Supplementary Ecological Information Report

**P6, Spring Park Data Centre
13th December 2024**

TG Report No. 15116_R10_VKC

Planning consultation: Redevelopment of site to deliver extension to existing Spring Park data centre campus consisting of (a) free standing data centre building (b) energy, power, and water infrastructure (c) site access and internal roads (d) site security arrangements (e) diverted Public Rights of Ways (f) hard and soft, green and blue, landscaping and (g) other ancillary and auxiliary forms of development

Photograph 2.1: Slope shaft in woodland approximately 95 m west of the site

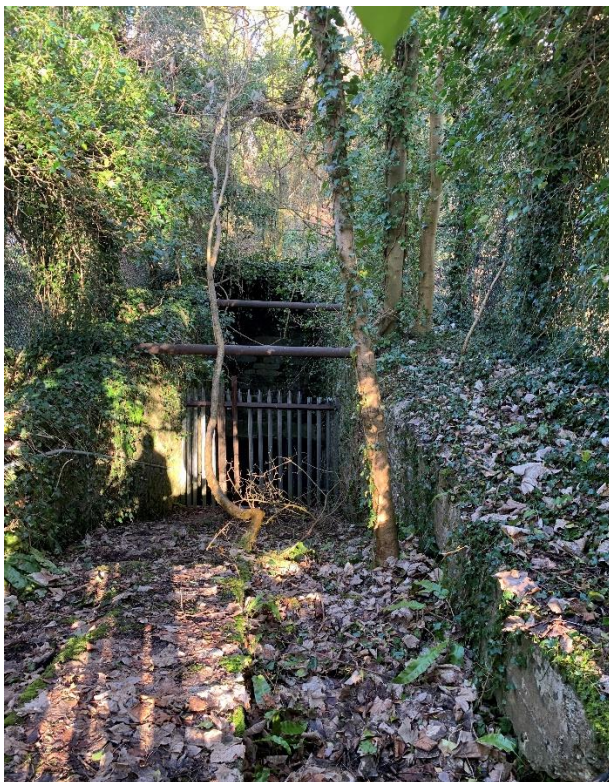
We note that a slope shaft bat roost is located nearby, but that due to access restrictions this feature was not included in the survey work submitted alongside the planning application. There are several air shafts and similar features in the vicinity of the site due to historical mining activity and the EclA does not specify the location of the slope shaft, other than mentioning that it is to the west of the site. We request further information on the location of the slope shaft bat roost to better understand the roosts proximity to proposed development and potential impacts on the roost.

- 2.2. A slope shaft bat roost, supporting a colony of lesser and greater horseshoe bats likely associated with the Bath and Bradford-on-Avon Bats SAC (as described in the EclA produced by TG), is located in an area of off-site woodland to the west of the site (see **Photograph 2.1** below). Further information on the location of the slope shaft has been requested by Natural England to better understand the roost's proximity to the proposed development and potential impacts on the roost.
